INNER PRIMARY CHAIN HOUSING/1200 AND 1340 CC MOTORCYCLES

HARLEY-DAVIDSON MOTOR CO., INC.

FIGURE 1. INNER PRIMARY CHAIN HOUSING

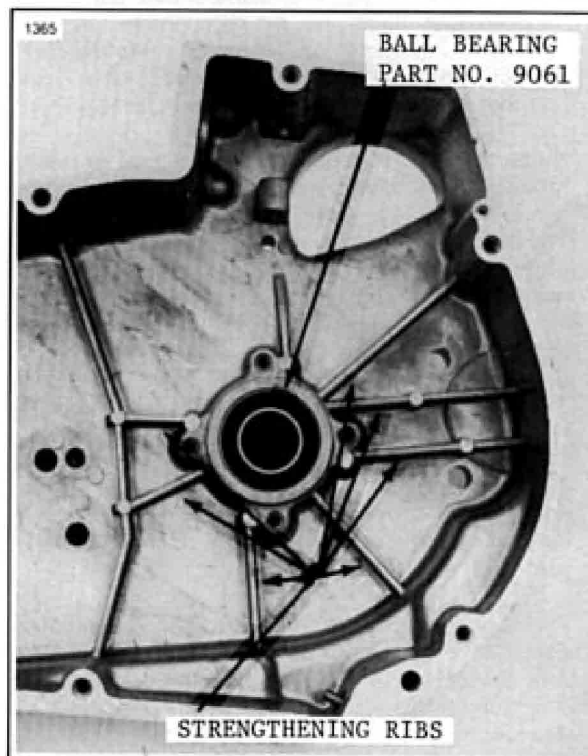
The transmission shaft ball bearing, Part No. 9061, located within the inner primary chain housing has exhibited shortened life in some 1200 and 1340cc motorcycles. This can be caused by a slight misalignment of the transmission shaft within the chain housing or slight flexing of the housing walls causing accelerated bearing wear.

An improved, strengthened inner primary chain housing has been put into production that should minimize this occurrence along with improved transmission shaft alignment techniques at the York assembly facility. The inner wall of the housing has been strengthened with ribs which greatly reduce flexing of the housing (see Figure 1.) These improved housings were put into production above V.I.N. number 25186 J0 on all 1200 and 1340cc models, and all Parts and Accessories stock contains the improved design. (See Paragraph 19 for affected part numbers and models.)

Whenever you encounter a motorcycle with a transmission shaft bearing failure, check for proper alignment of the transmission shaft (see "Transmission" section of 1978½ FL/FX Service Manual) and inspect the inner primary chain housing for evidence of cracking and/or distortion around the bearing and inner walls of the housing. If such cracks or distortion are evident, replace with strengthened inner housing unit and discard the old one.
